RECEIPT DATE: 12/30/16 **ONSITE SEWAGE DISPOSAL SYSTEM** P 559890
 APPROVAL DATE: 11/08/16 **PERMIT: CONSTRUCTION** A _____
 PROPERTY ADDRESS: 3461 Daisy Road
 SUBDIVISION: _____ LOT: 10 TAX ID: 04-319923
 CONTRACTOR: South Carroll Backhoe EMAIL: scbackhoe@comcast.net
 CONTRACTOR ADDRESS: 4410 Salem Bottom Road, Westminster, MD 21157 PHONE: 410-596-3618

B.A.T. SYSTEM SITE PLAN
3461 DAISY RD
SINGLE FAMILY DETACHED
GLENWOOD
DEED REF. LIBER 16913 / FOLIO 094
ZONED RC-DEO

RE: 3461 Daisy Road BAT plan

I have reviewed the BAT plan for the above referenced property and have the following comments for revision:

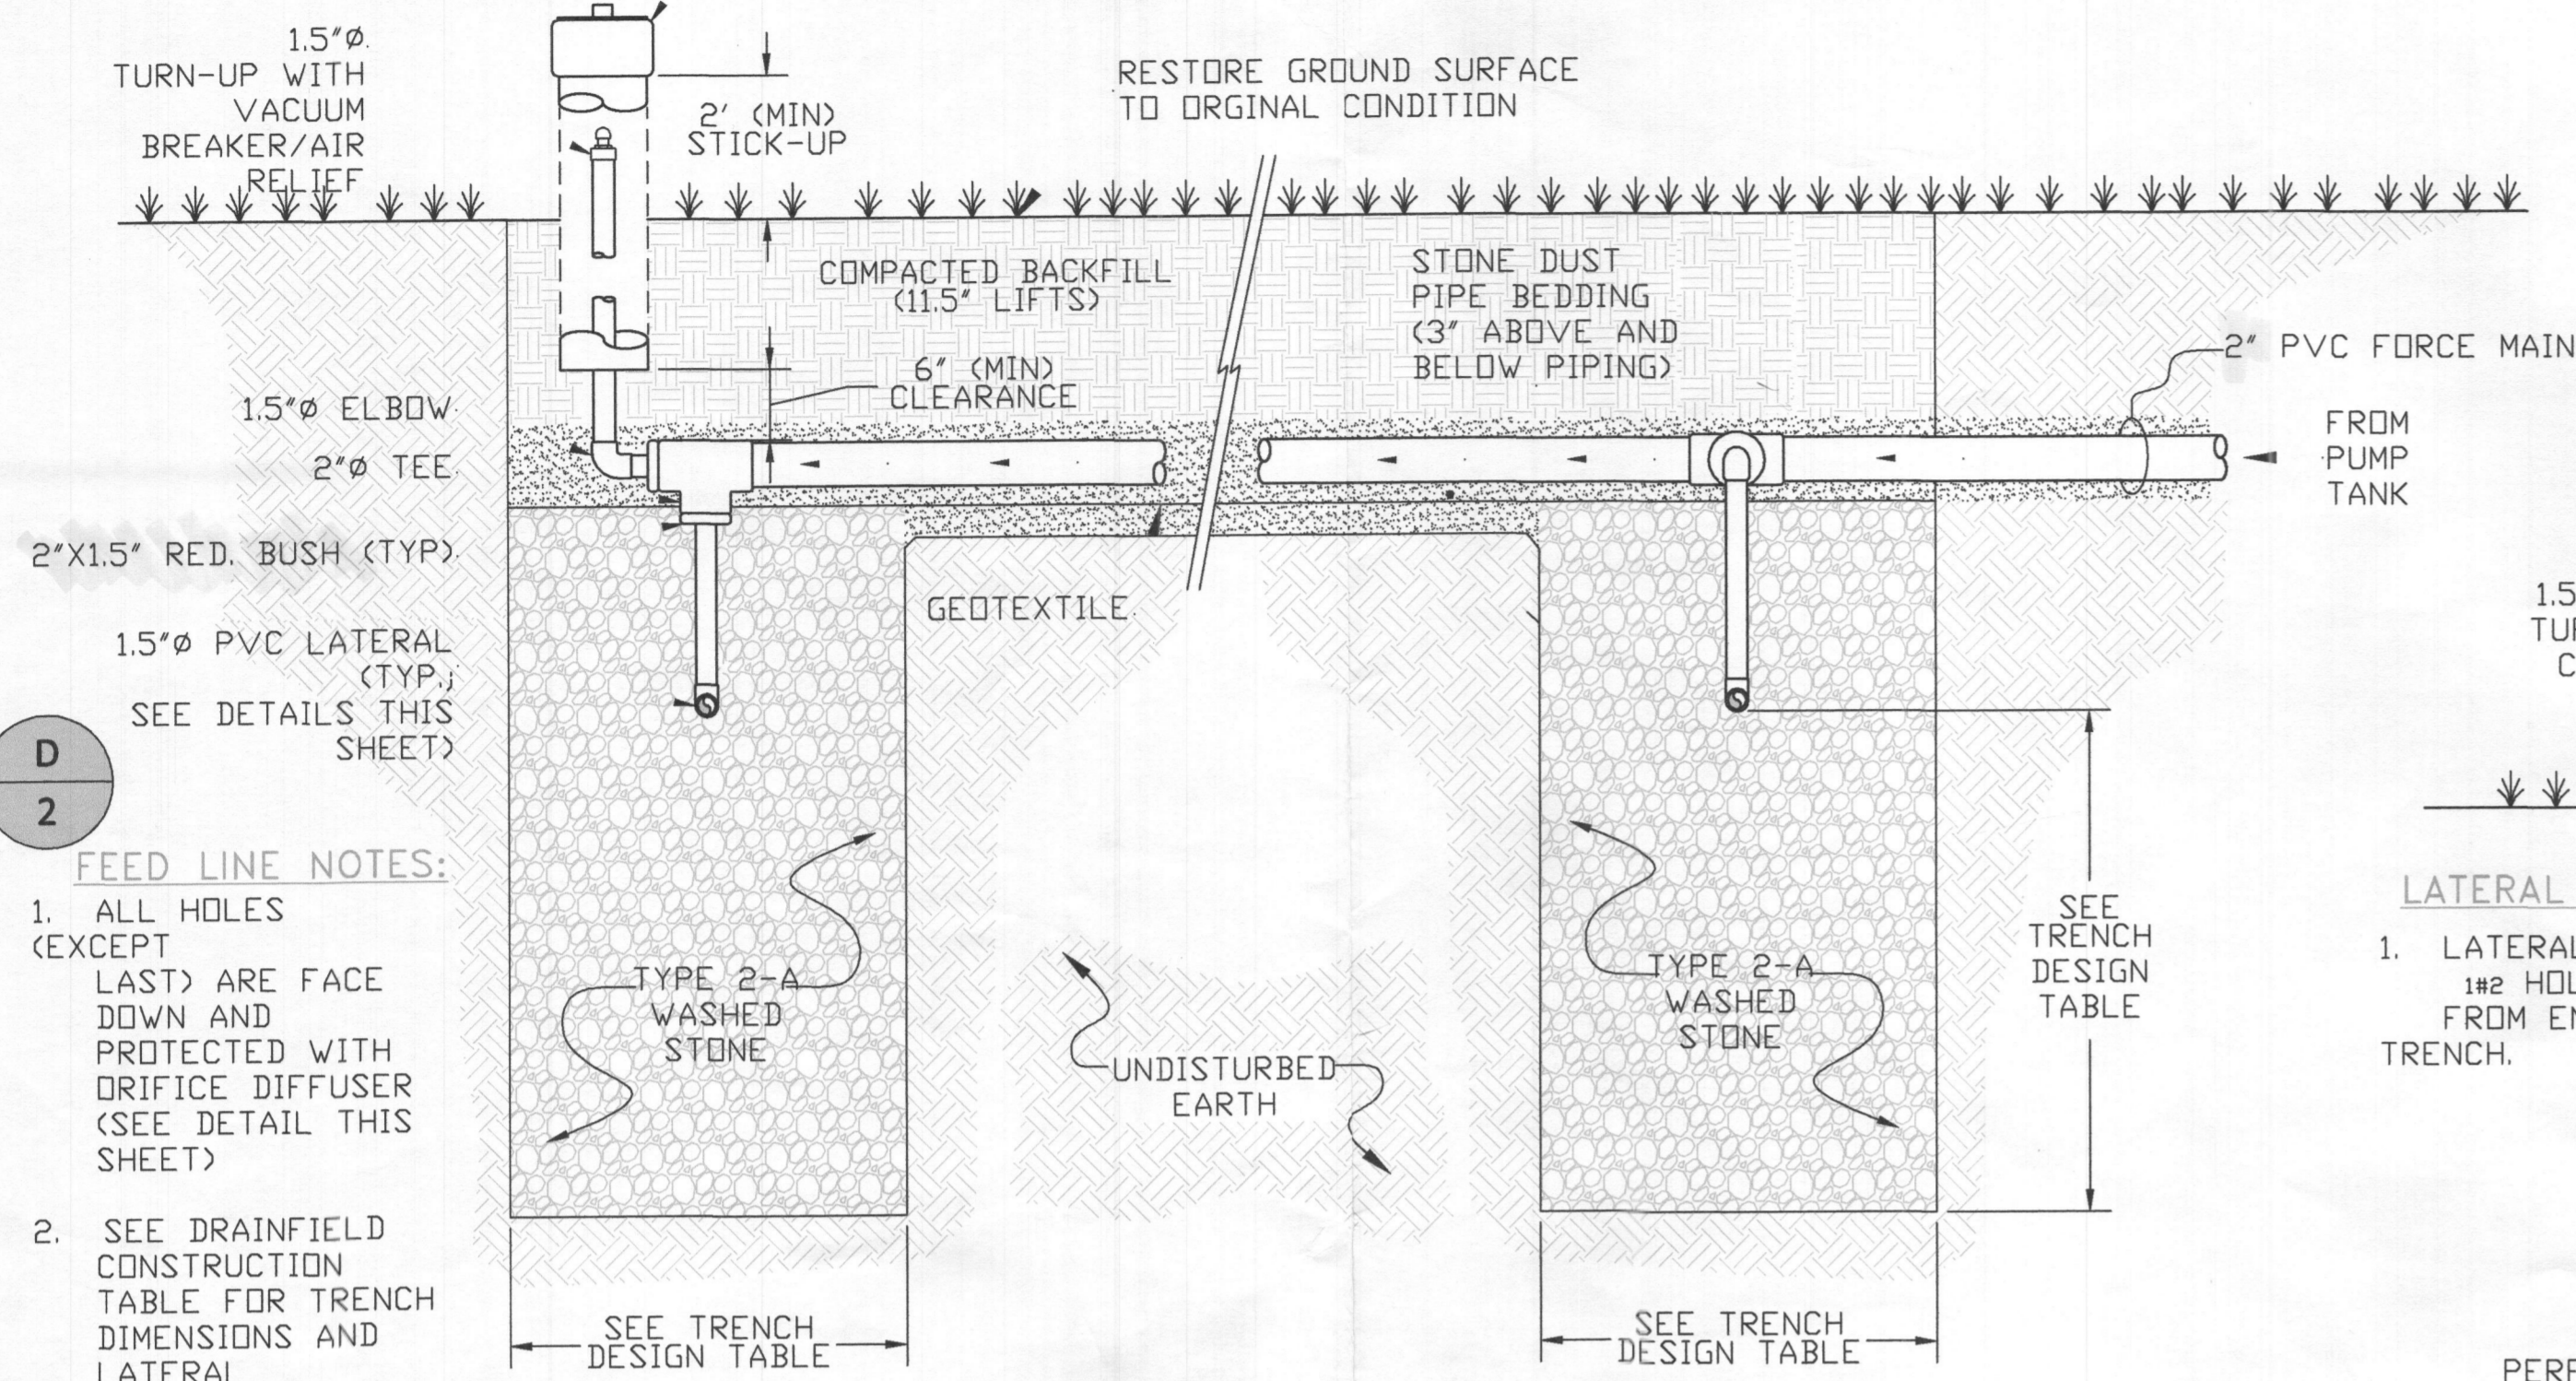
- The sewage disposal system must utilize a low pressure dosed drainfield as a condition of the downgrade well variance. The BAT plan shows a gravity trench design. The design plan must show all details necessary to install a low pressure dosed system, including detailed calculations of the number of perforations, perforation spacing, lateral diameter and length, lateral flow, etc. A diagram of the force main, manifold, and lateral network must be shown. A detail of the lateral turn-ups must be shown. Details of the dosing and total dynamic head including calculations of friction head must be shown. A pump curve and a specific pump model must be shown. A cross section of a properly sized pump tank and details of the pump float positioning and calculations of appropriate emergency storage must be shown.

- The invert is listed as 5'. The maximum allowed invert depth is 4' below grade, even if effective area starts below that depth. Correct depths in the system design details accordingly.

- Remove note 10 and health officer signature block.
- Correct the legend to only include symbols being used in the diagram.

DOSE PUMP CONTROL PANEL

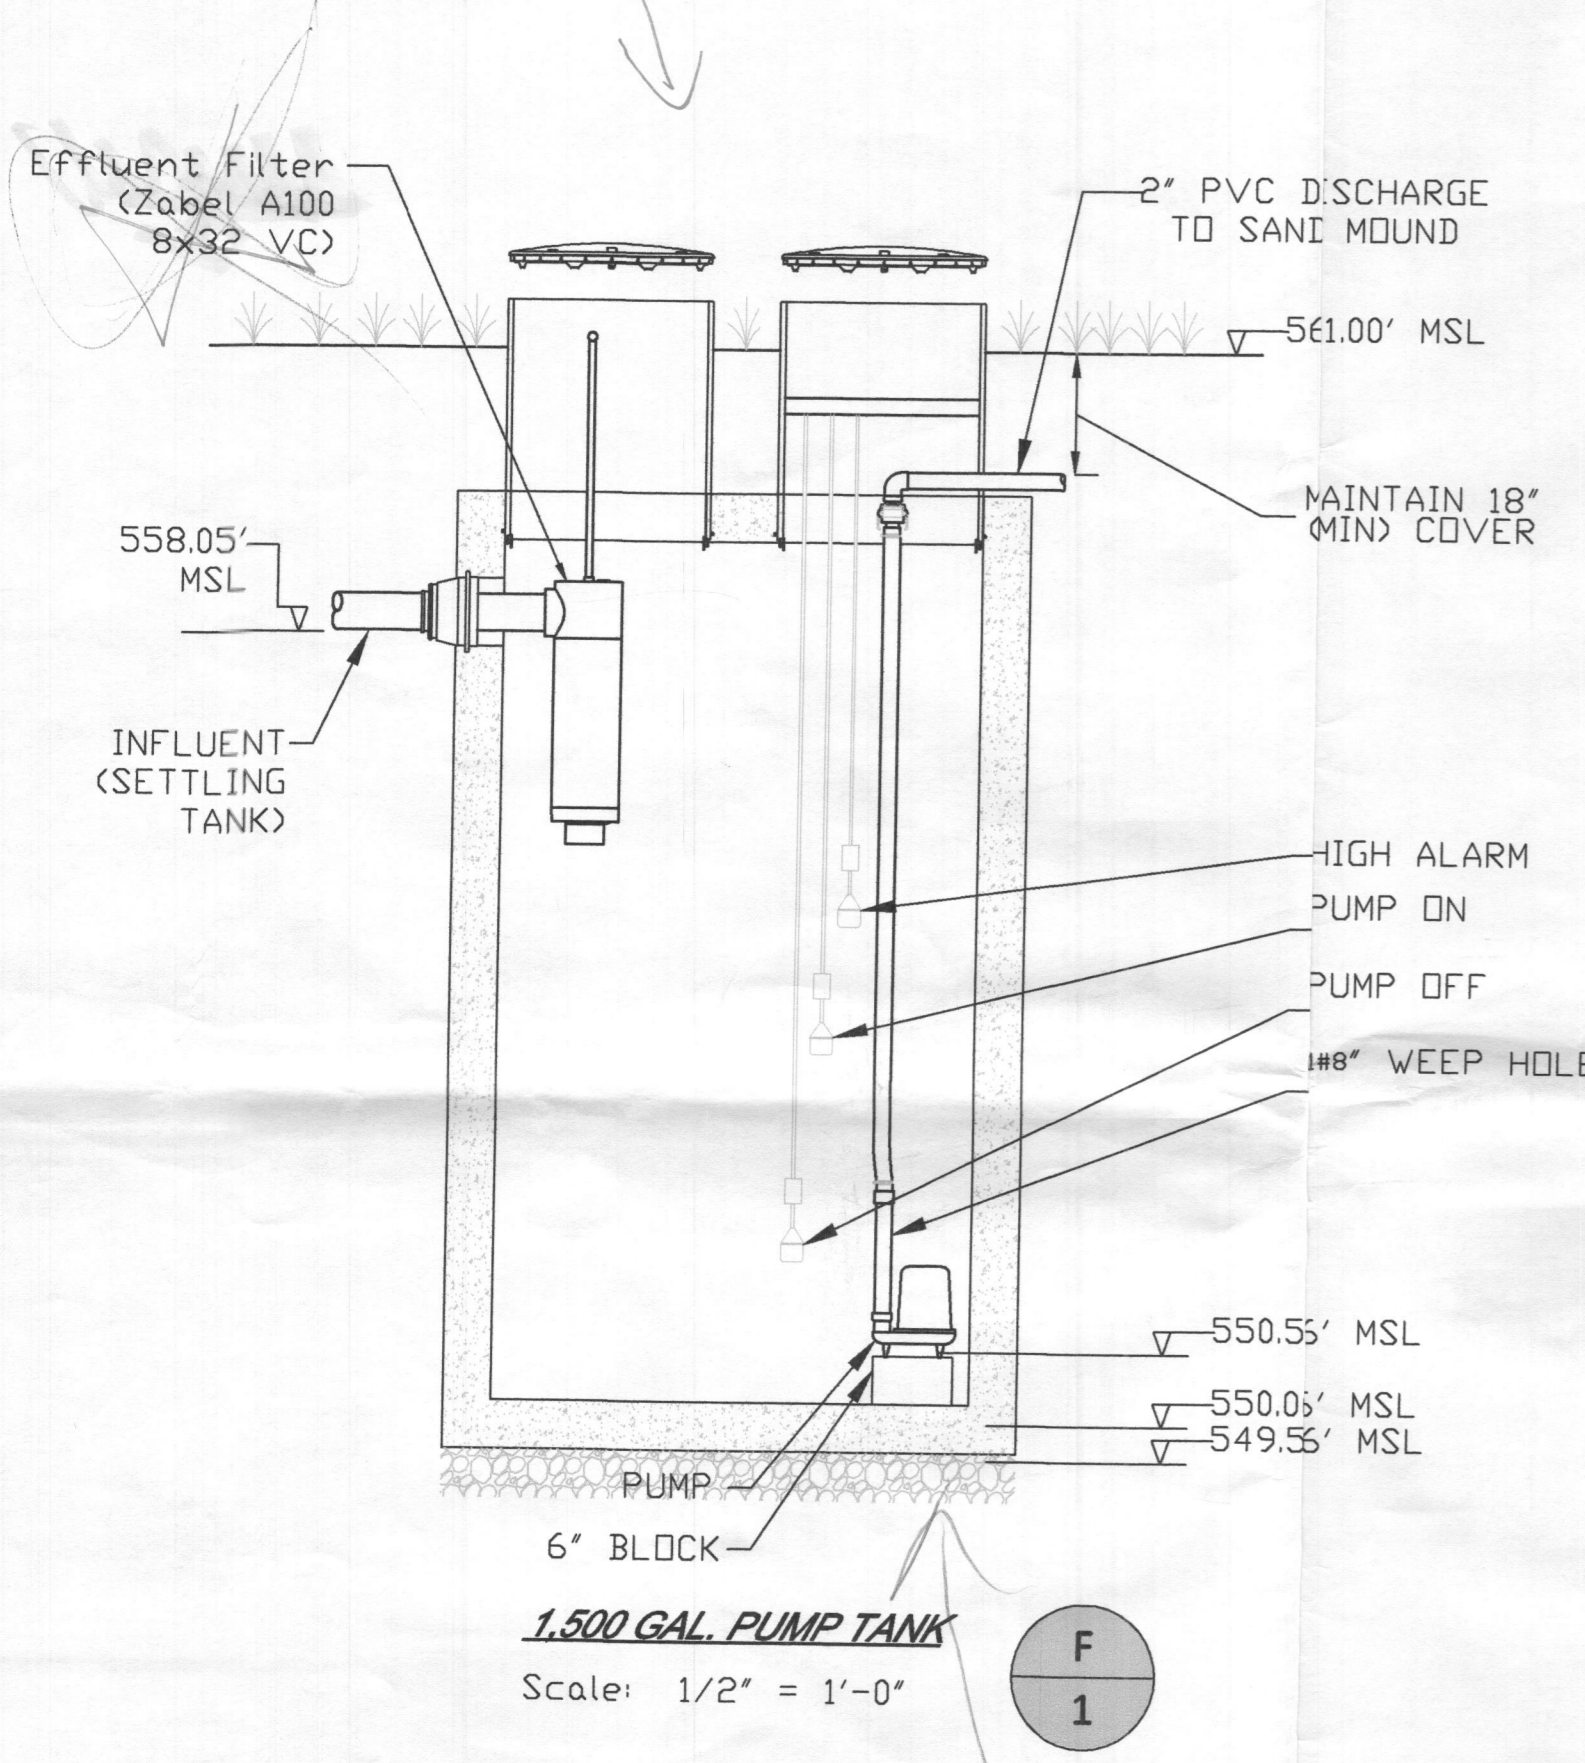
Tank Spec for Vertical Tank (Kitchen Tank)
 1/4" pump set inside float.
 Told contractor 'OK' to use
 1500 G P.F. from Relay Unit

Time closed
 OK to do Demand Dose

Dose 3x Daily @ 2.1m
 (1225 Dose)
